Radium-223 Dichloride: Bayer Responses to NRC Questions

November 8, 2012

On September 19, 2012, Bayer received 9 questions from the United States Nuclear Regulatory Commission (U.S. NRC). Bayer responses to the questions are provided below in a question and response format.

Figure 1: Actinium-227 decay chain

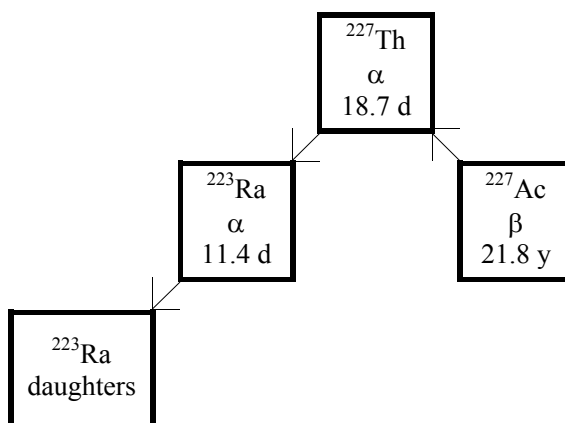
3. Please provide data to support that there are no long lived contaminants in radium-223 dichloride.

Quality control procedures are designed to exclude the presence of long lived contaminants in radium-223 dichloride. Potential long lived contaminants originating from the original production of the Ac-227 source material are rigorously analyzed in each Ac-227 generator as part of the raw material release procedures to exclude the possibility for long lived radionuclide impurities in the Ac-227 generators.

Based on the production method for radium-223 dichloride from Ac-227 generators, the most likely potential long lived contaminants are from the immediate parent radionuclides, Ac-227 ($t_{1/2} = 22$ y) and Th-227 ($t_{1/2} = 18.7$ d) ([Figure 1](#)). Tests for Ac-227 and Th-227, are performed on each individual batch of radium-223 dichloride produced as part of the overall batch testing.

To date, approximately 300 batches have been tested for residual Th-227 and Ac-227; no result above the limit of detection has been obtained.

Figure 2: Diagram of Apparatus to Measure Radon-219 Volatility

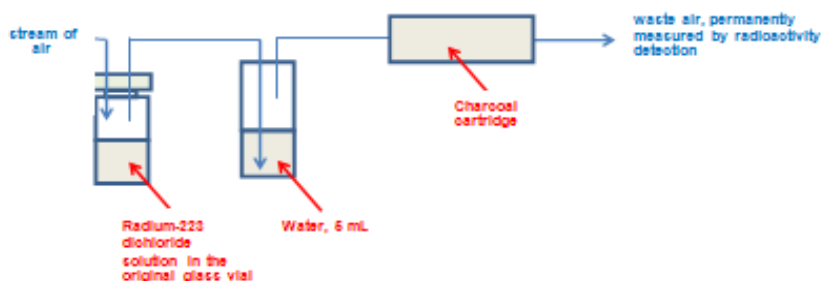
4. Please provide data to support that radium-223 dichloride is not volatile or easily respirable due to the low inhalation Annual Limit on Intake (ALI) stated in Title 10 Code of Federal Regulations (CFR) Part 20.

Furthermore, Bayer Pharma AG (Wuppertal, Germany) investigated the likelihood of radon-219 volatility out of a radium-223 dichloride solution by using the following apparatus.

The radium-223 vial contained a total radioactivity of 2.4 MBq in a 6 ml aqueous solution, resulting in an activity concentration of 402 kBq/ml. This headspace of the vial was continuously purged by a stream of fresh air for three hours. The air was passed through a water filled flask and subsequently through a charcoal cartridge. After three hours, no radioactivity above background was detected by gamma spectroscopy in either the water of the flask or in the charcoal. This measurement result is in agreement with the theoretical calculations and measurements made in liquid scintillation cocktails as given above, all indicating that no significant amounts of radon-219 are likely to be released from a radium-223 dichloride solution. Thus, radium-223 dichloride is not easily respirable given the relatively low inhalation ALI of 0.7 μ Ci for radium-223 pursuant to 10 CFR Part 20.
